FEDERAL AID PROJECT
PROJECT NO.
CSJ: 0610-03-095
**TITUS COUNTY
IH 30**

FOR WORK CONSISTING OF CONSTRUCTING WEIGH STATION AND RAMPS

60% PLANS

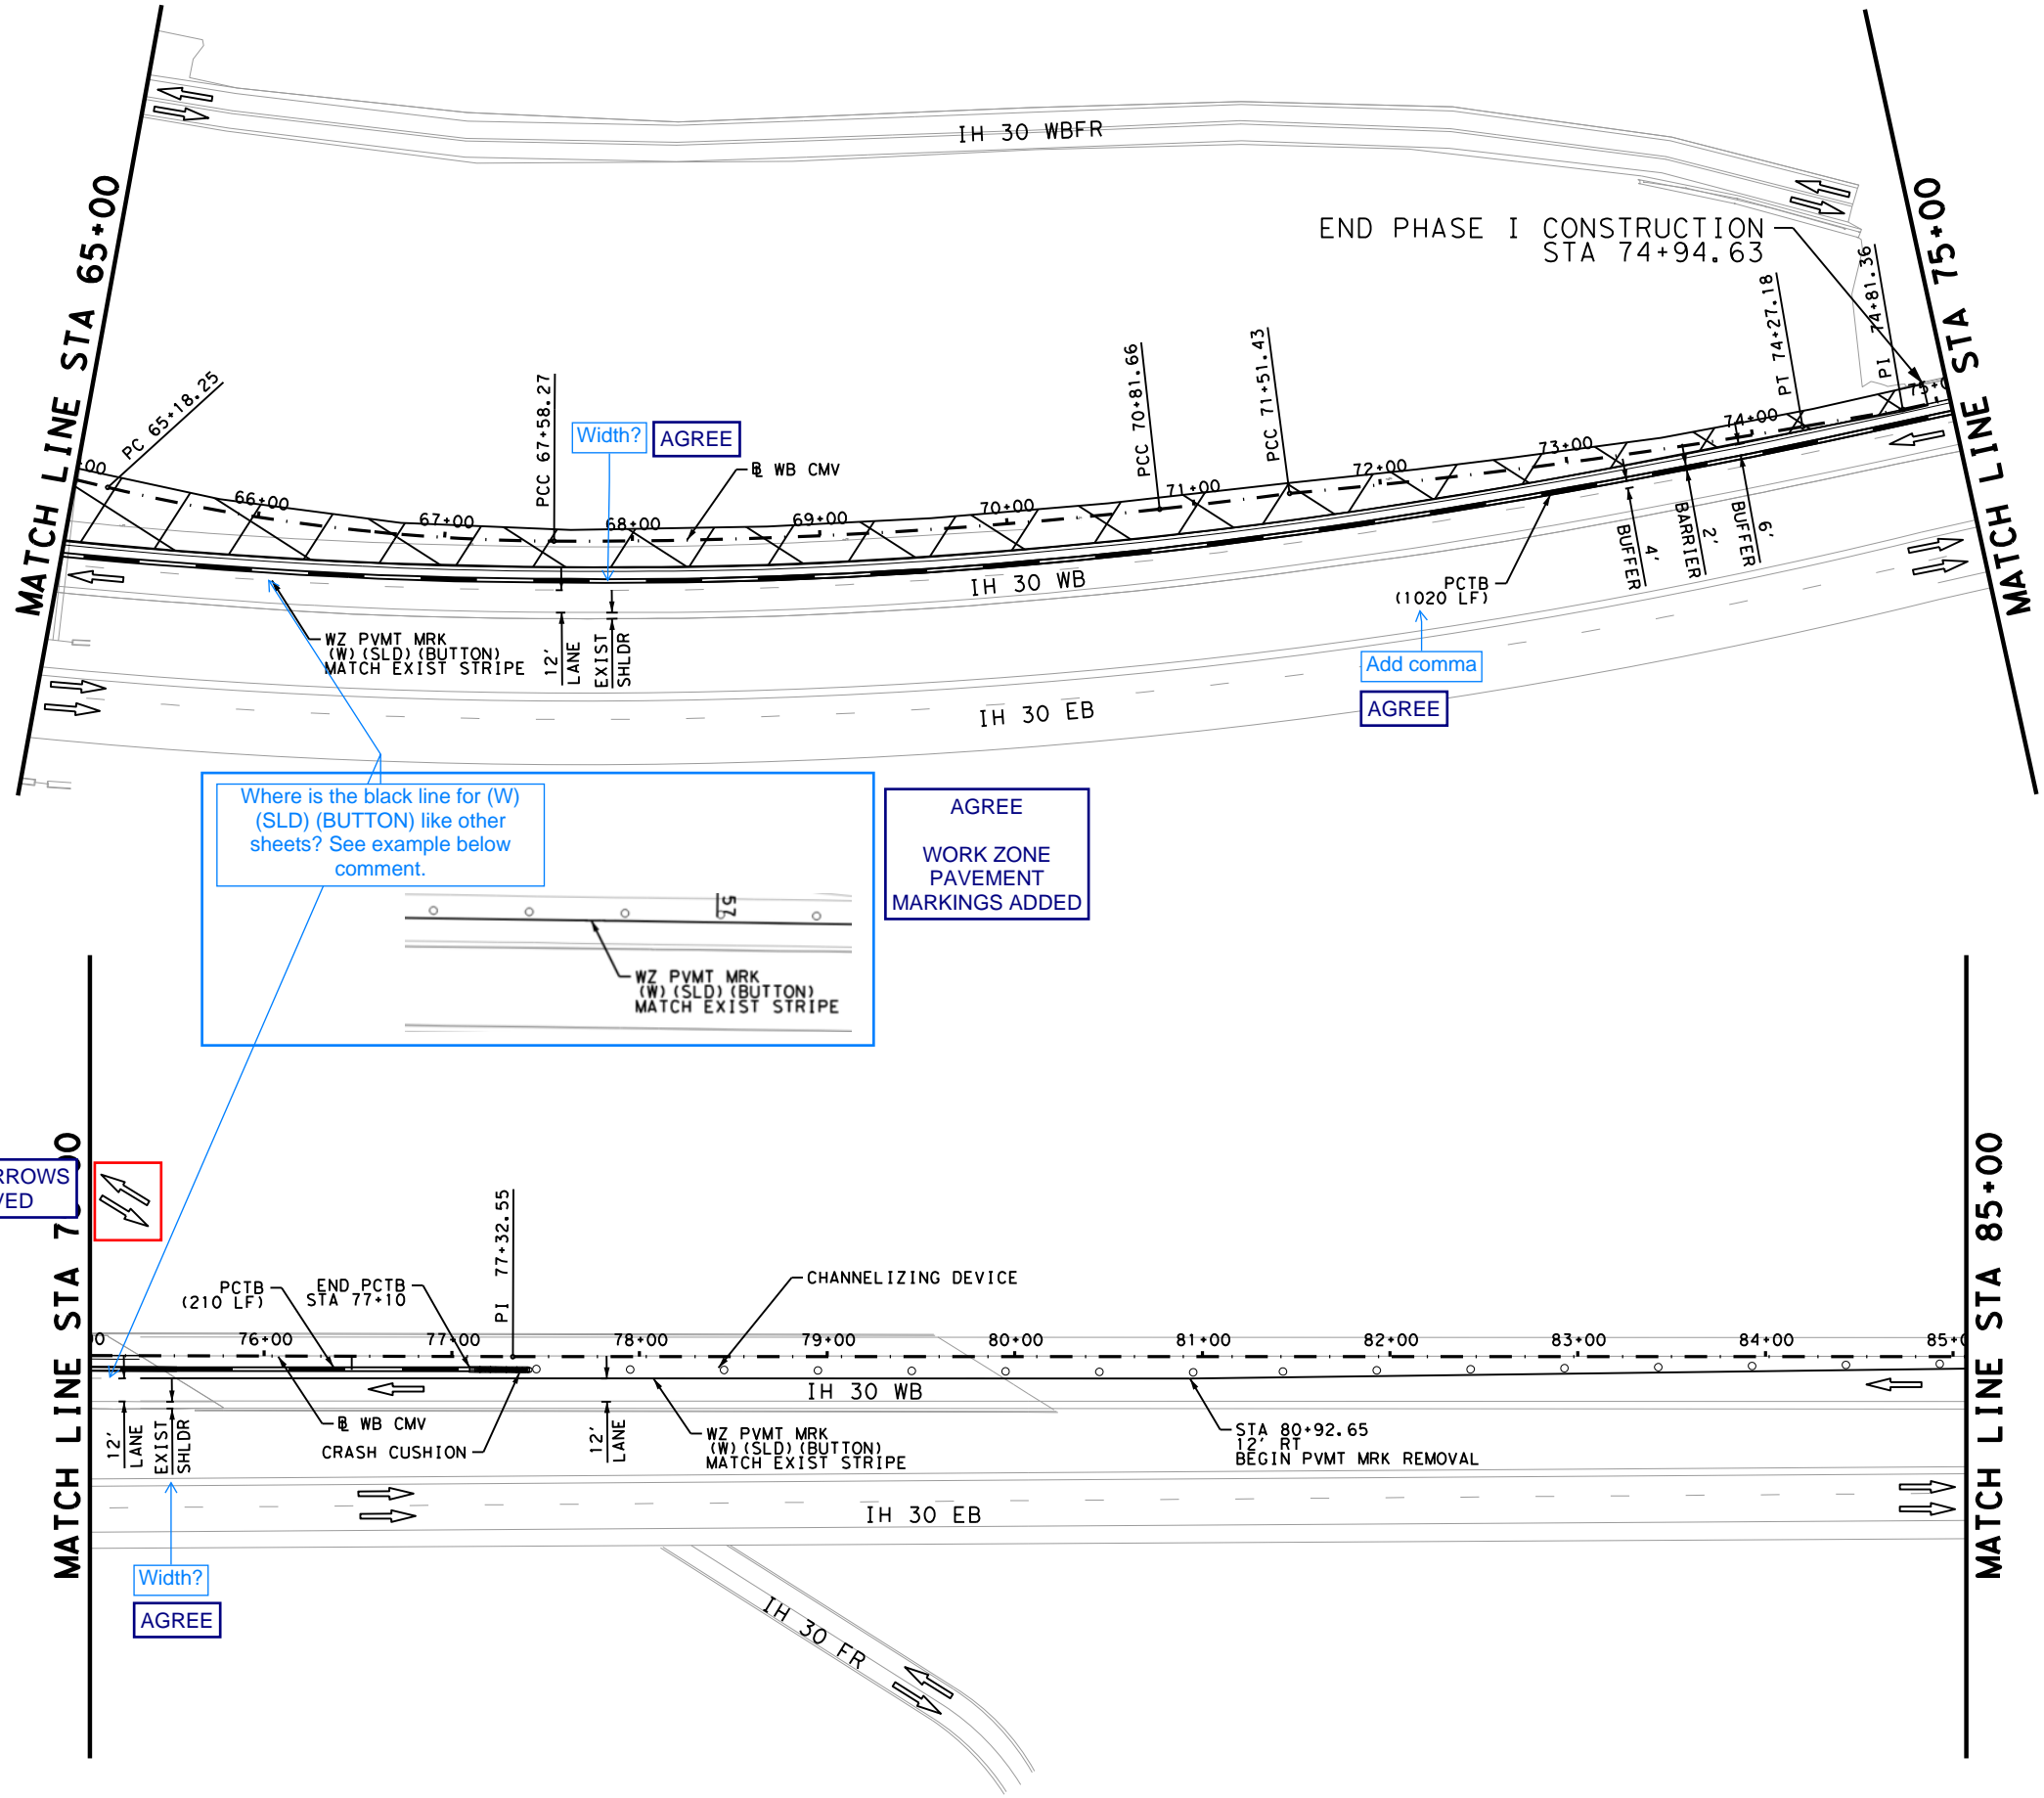
Where is the black line for (W) (SLD) (BUTTON) like other sheets? See example below comment.

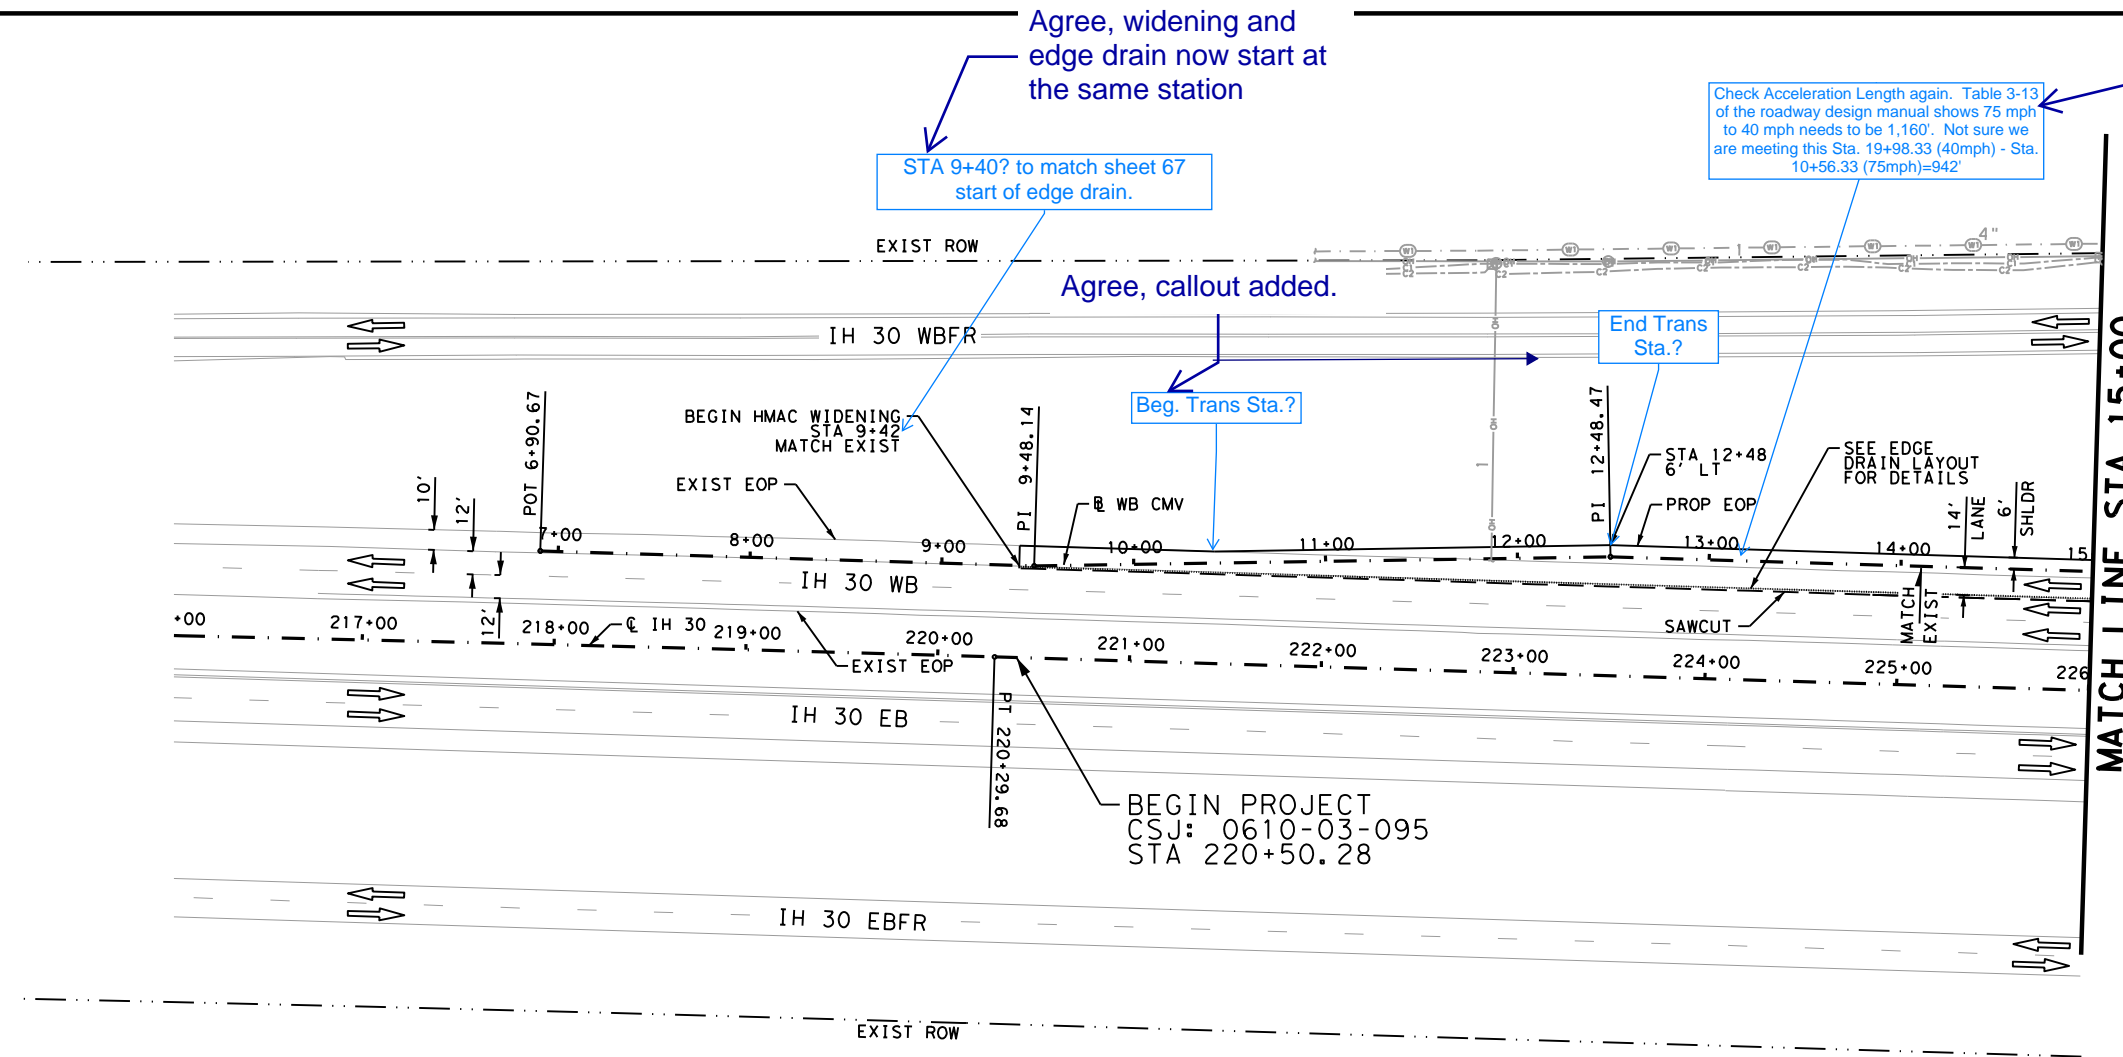
780'.
The nose of the gore is equat 2-ft around STA 18+60.
STA 18+60 (50 mph) - STA 9+45 (75 mph) = 915'

DGN#	FED. NO.	STATE	FEDERAL AID PROJECT NO.	HIGHWAY NO.
CHK DGN#	6	TEXAS		IH 30
DWG#	DIST.	COUNTY	CONT. NO.	SECT. NO.
CHK DWG#	ATL	TITUS	0610	03
			095	60

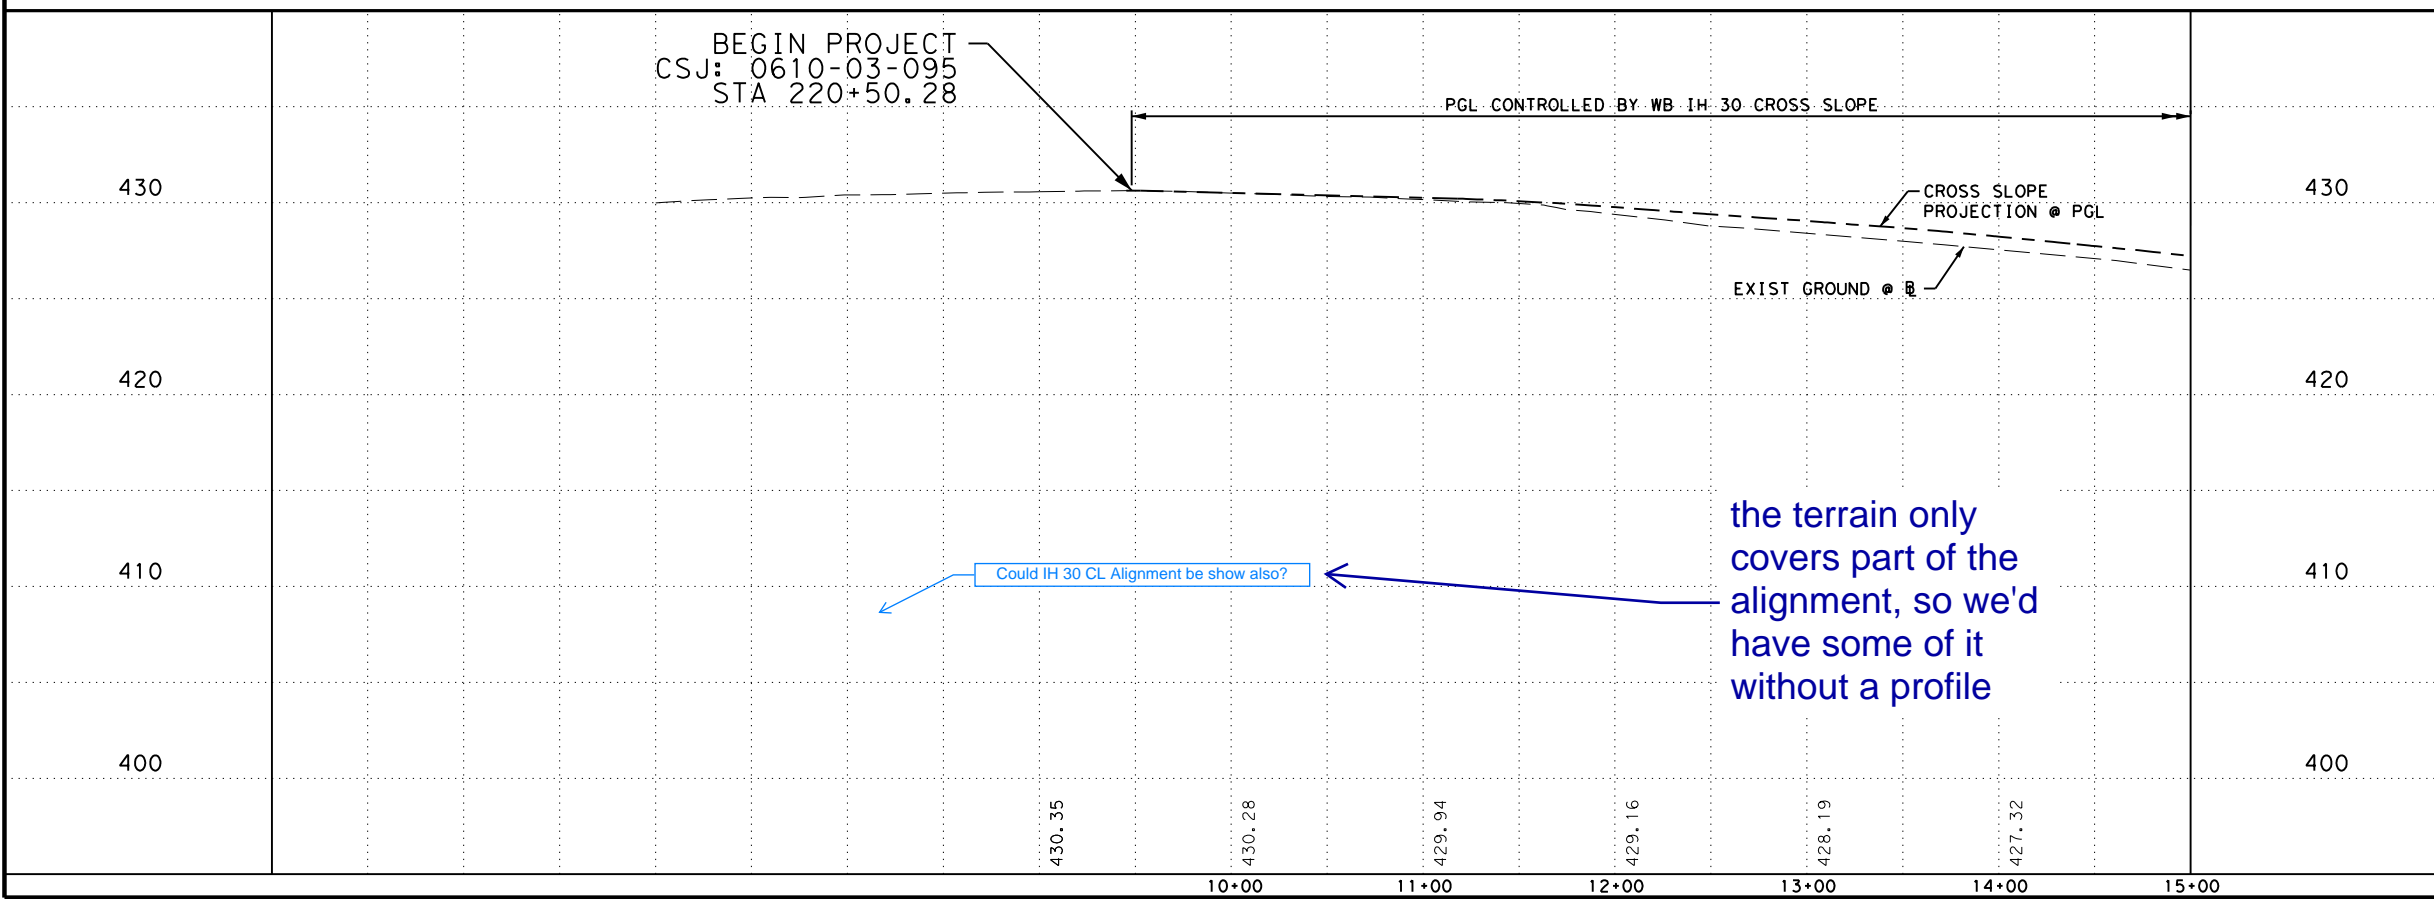
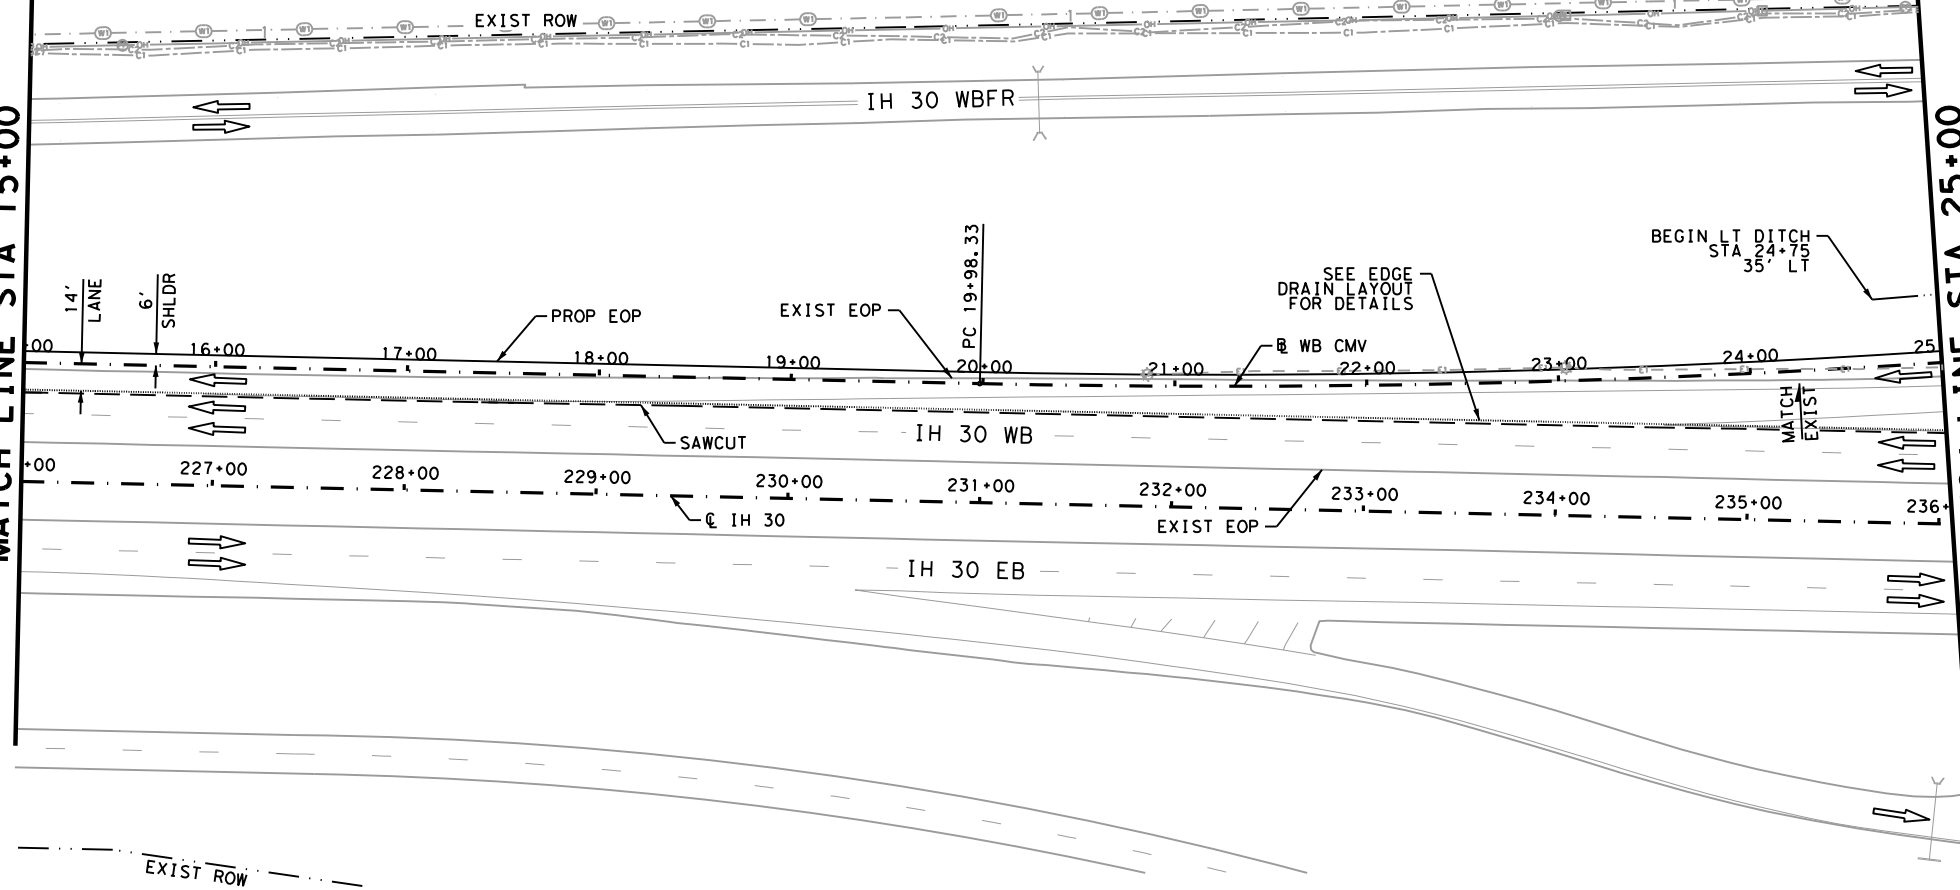
TITLE SHEET SAYS 70 MPH DESIGN SPEED

The ramp design speed should be 50 mph. 5,700 ft radius with 2% cross-slope = 50 mph
